Three Mile Island Nuclear Station, Unit 2 (TMI-2)
Docket No. 50-320
Operating License No. DPR-73
Technical Specification Change Request No. 014

Operating License No. DPR-73
Docket No. 50-320
Technical Specification Change Request No. 014

Three Mile Island Nuclear Station Unit 2 (TMI-2)
Operating License No. DPR-73
Docket No. 50-320

Technical Specification Change Request

Figure 2.1-1

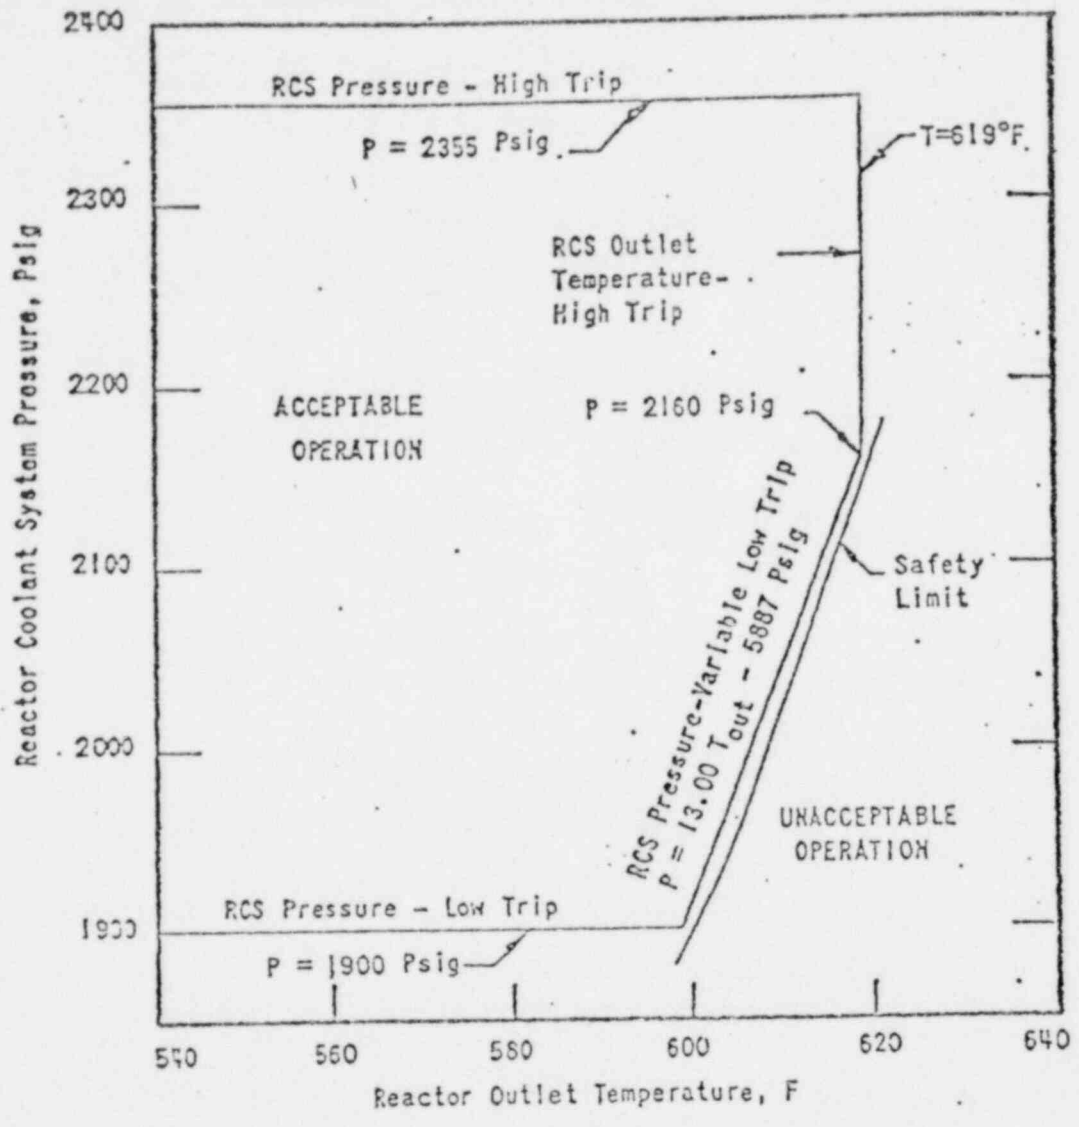
The licensee requests that the attached changed pages replace 2-5, 2-6, 3/4 2-13, 3/4 3-3, and 3/4 3-13, and that the attached changed figures replace figures 2.1-1, 2.1-2, 2.2-1 and 2.2-2. Also included for your information and use are changed pages B 2-1, B 2-2, B 2-6 and figure 2.1, all of which are part of the "Bases" Section of the TMI-2 Technical Specifications. These pages will be distributed to Technical Specification (T.S.) copyholders upon approval of this change request. However, in accordance with 10 CFR 50.36, the bases are not considered part of the T.S., and therefore, changes in them do not require your approval.

Due to the recent concern over wear encountered in the Fuel Assembly (FA) holddown latch assemblies in units similar to TMI-2, caused by vibration of Burnable Poison Rod Assemblies (BPRAs) and Orifice Rod Assemblies (ORAs), it is believed necessary to install retainers on the BPRAs and on two modified ORAs and to remove the remaining ORAs. Installation of the BPRA retainers reduces hot assembly flow by less than 1% and removal of all 40 ORAs would increase bypass flow by only 1.6%. These effects on the system flow characteristics are very slight and when they are combined with the increased flow presented in the attached proposed changes, the DNBR safety margin is actually increased. Although the present safety margins are adequate to compensate for the changes in flow distribution brought about as a result of these core alterations, we feel that system flow should be increased to ensure even larger DNBR safety margin.

Several changes included in this change request are not related to ORA removal and BPRA retainer installation. The first of these changes is the increase in RCS Pressure - low trip setpoint in Table 2.2-1 from 1800 psig to 1900 psig. This change is being made for greater operating flexibility and to allow for a backup function in case of a small break LOCA although it will most likely never be used because the RCS pressure - variable low should occur first. It is also being made to increase the margin to HPI so that a rapid depressurization will not unnecessarily inject EPI as frequently as would occur with less margin. As a result of this increase in the RCS Pressure - low trip setpoint, it is correspondingly necessary to increase the manual bypass by 100 psi to 1820 psig to incorporate 1820 psig as the new high pressure trip during startup in shutdown bypass. This will enable startup to be performed more easily and will continue to maintain the same margin previously used to allow for instrument errors. Since the change in RCS Pressure - low trip setpoint is in a conservative direction, it is bounded by previous analyses and therefore does not require an additional safety analysis.

The rod bow penalty which is not directly related to ORA removal has been revised to correctly reflect the KRC Rod Bow Model. The original Technical Specification was prepared using the B&W Rod Bow Model and during investigation into the removal of the ORAs was discovered and is corrected herein. The imbalance curves in Figures 2.2-1 and 2.2-2 are also being corrected to account for an initial misinterpretation of the positive offset error equation.
